**WOKINGHAM
BOROUGH COUNCIL**

Full Planning Approval Consultation

Application Number: 252144

Proposal: Full application for the installation of an access track and bund, and erection of 2 no. agricultural buildings following demolition of the existing buildings. (Part retrospective)

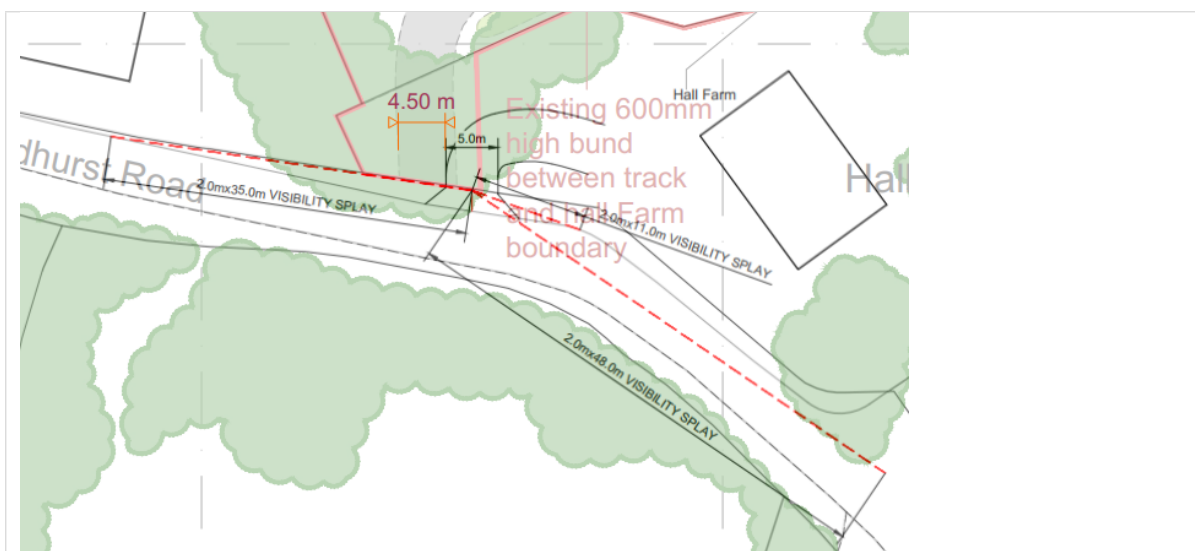
While the applicant confirms that the proposed access track is an upgrade of track materials at the existing roadside access point, the proposed access track does not align with the approved access in Planning Application 222706.

It has been previously requested the relations of the approved access and the proposed access track to be submitted on a plan, which is still not included in this proposal. The Highways therefore have overlaid the approved access point with the proposed access track, showing that the proposed access is being displaced by circa 4.5m to the west:

The approved visibility splays only apply to the existing point of access. If the applicant intends to relocate the access at proposed, the visibility splays shall be reassessed. Lower Sandhurst Road is subject to 60mph speed limit. According to the DMRB, visibility splays of 2.4m x 215m to the nearside edge of the carriageway in both direction of Lower Sandhurst Road shall be assessed, which is unlikely to be achievable.

The applicant may wish to revise the proposed position of the access track to align with the approved access.
